SERVICE BULLETIN

from: TRIO-KENWOOD COMMUNICATIONS, INC.

56

SUBJECT: TS-180S DFC

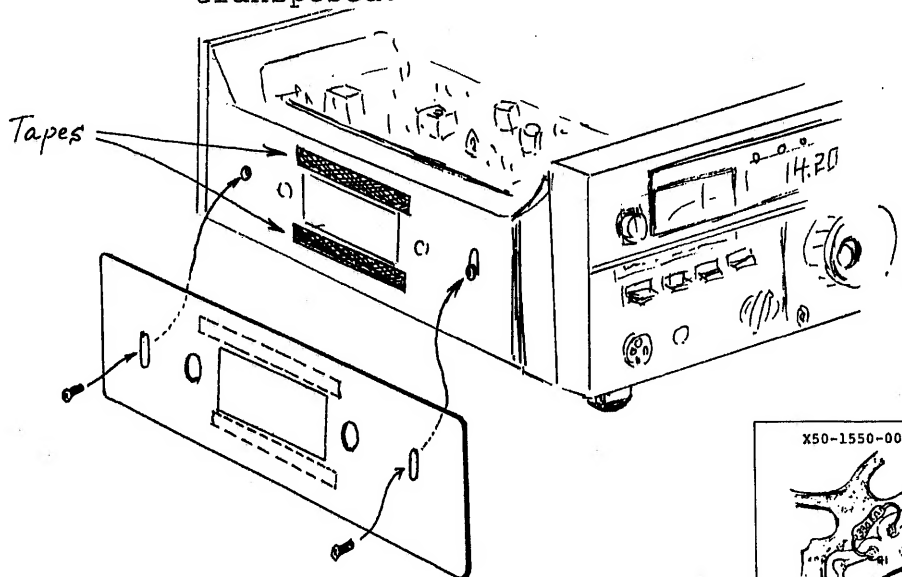
For complaints of either induced power supply hum, or intermittent frequency stability while using the DFC, perform the following changes to the VCO unit X50-1550-00:

- *1. Install a 330K ohm resistor between Q11 G1 & the 8V line. Connect from L7 at C12 to Q11 G1, at R35.
- *2. Replace L12 68uH with new part L40-6831-21.
- *3. Replace L13 150uH with new part L40-1541-27.
- *4. Install magnetic shield as illustrated. Use the two existing screws, plus double faced tape to prevent vibration.
